**RE: 15575 El Gato Lane**

I reviewed the drawings and evaluated the neighborhood context. My comments and recommendations on the design are as follows:

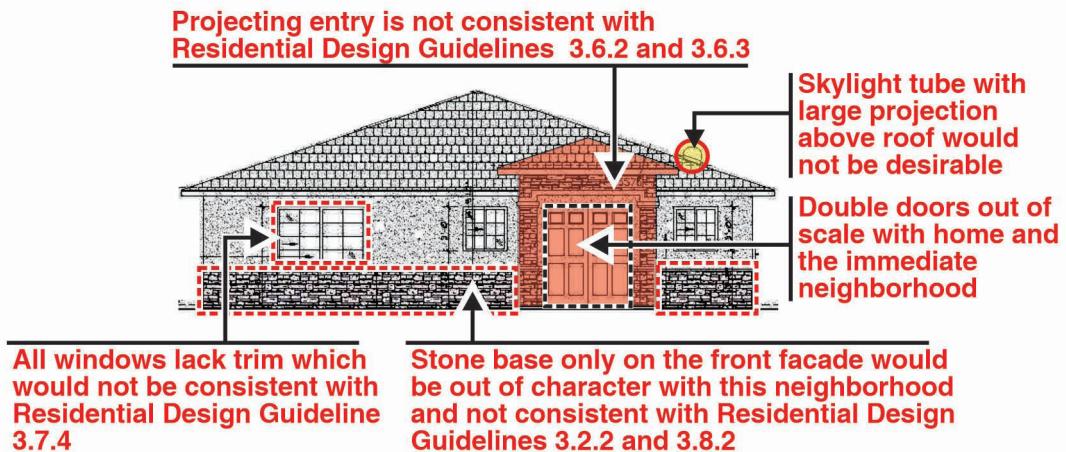
1. The proposed added projecting entry is out of character with the neighborhood and would not be consistent with Residential Design Guidelines 3.6.2 and 3.6.3.

2. The stone base would not be consistent with Residential Design Guidelines 3.2.2. It is a material foreign to its immediate neighborhood and is used only on the front facade.

4. The skylight sun tunnels shown on the drawings depict a prominent dome which could be an unwelcome night light.

1. Eliminate the projecting entry.
2. Eliminate and front facade stone base or carry it consistently around all sides of the home.
3. Eliminate the double front entry door in favor of a single door with sidelights.
4. Add trim to all windows to be consistent with Residential Design Guideline 3.7.4.
5. Provide consistency in the proportions of all smaller window pane proportions in lieu of the currently proposed wide variety in proportions and orientation. Typically these panes should be vertical or square, not horizontal.
6. The dividers in the larger window panes should be true or simulated divers per Residential Design Guideline 3.7.4.
7. Select skylight sun tunnels with flat or low profile tops to minimize nighttime glow.

#### **Projecting entry is not consistent with Residential Design Guidelines 3.6.2 and 3.6.3**

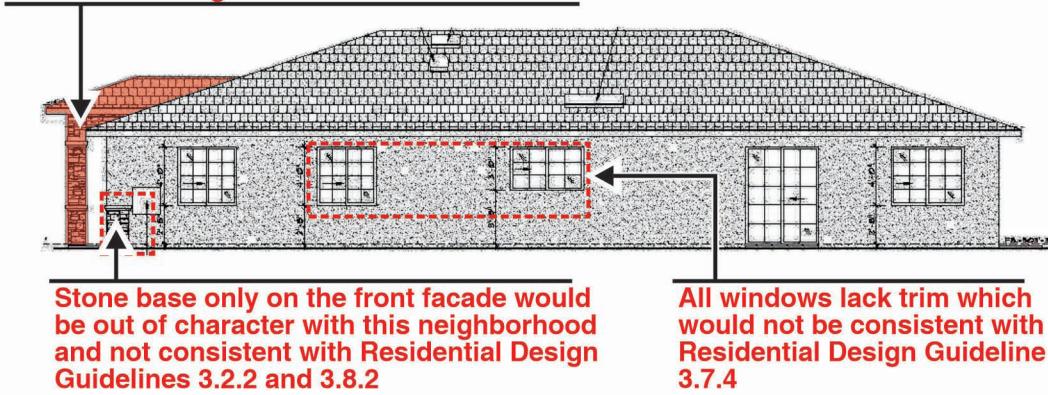
*Avoid formal entries (above) in neighborhoods with informal homes and in Ranch Style neighborhoods where entries are located under roof eaves*

*Currently Proposed Front Facade*

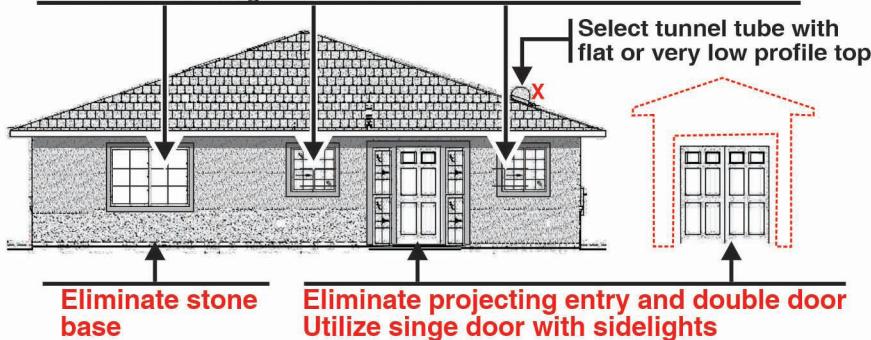
3. All windows lack trim which would not be consistent with Residential Design Guideline 3.7.4.

**Add trim on all windows**

**Provide consistency of individual window pane proportions**

**Use true or simulated divided panes**
